Access Compliance Report

Public Rights-of-Way

(Curb Ramps)

Intersection ID: 14093	Main Street: E_4TH_ST	Cross Street: QUEENS_RD	Location: W
ADA ID: F1E7CA415713	Ramp Type: PerpDiag	Initial Pass/Fail: Fail	Overall Compliance: No
Severity Score: 12.5			
Codes/Mitigation Info/Possible Solution		Field Measurements/Component Compliance

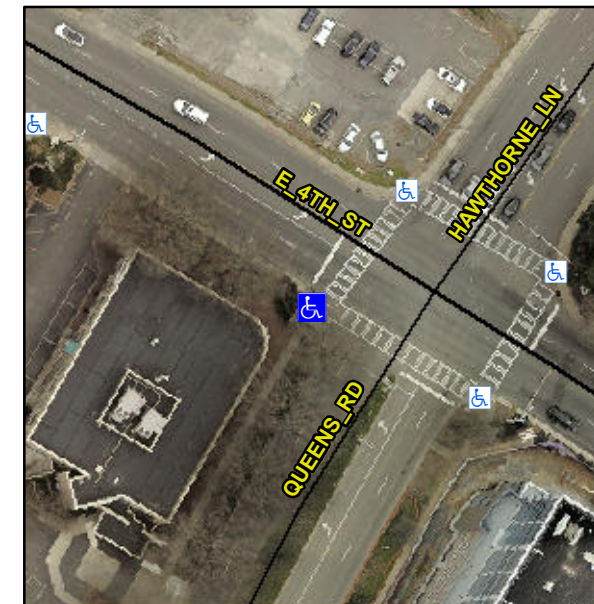
Not Found, R304.2.2

Compliance	Description	Data	Compliance	Description	Data
N/A	Ramp Length (in)	48.0	No	Ramp Slope (%)	10.1
Yes	Ramp Width (in)	48.0	Yes	Ramp XSlope (%)	0.6
N/A	Flare Type LT	N/A	N/A	Flare Type RT	N/A
N/A	Flare Slope LT (%)	N/A	N/A	Flare Slope RT (%)	N/A
N/A	Flare Traversable LT?	N/A	N/A	Flare Traversable RT?	N/A
N/A	Landing Length (in)	N/A	N/A	DWS Provided?	N/A
N/A	Landing Width (in)	N/A	N/A	DWS Contrast?	N/A
N/A	Landing Slope (%)	N/A	N/A	DWS Length (in)	N/A
N/A	Landing X Slope (%)	N/A	N/A	DWS Full Width?	N/A
N/A	Landing Curb? (Y/N)	N/A	N/A	DWS Offset (in)	N/A
N/A	Shared Landing?	N/A			
N/A	Gutter Ponding?	N/A	N/A	Gutter Slope (%)	N/A
N/A	Gutter Lip Ht (in)	1.0	N/A	Gutter X Slope (%)	N/A
N/A	Painted X Walk1?	Yes	N/A	Painted X Walk2?	Yes
	X Walk 1 Direction	To SE		X Walk 2 Direction	To NE
N/A	X Walk 1 Width (in)	108.0	N/A	X Walk 2 Width (in)	103.0
	X Walk 1 Slope (%)	5.4		X Walk 2 Slope (%)	4.7
	X Walk 1 X Slope (%)	3.8		X Walk 2 X Slope (%)	4.7

Remove & Replace Curb Ramp With Two New Directional Ramps or Equivalent.
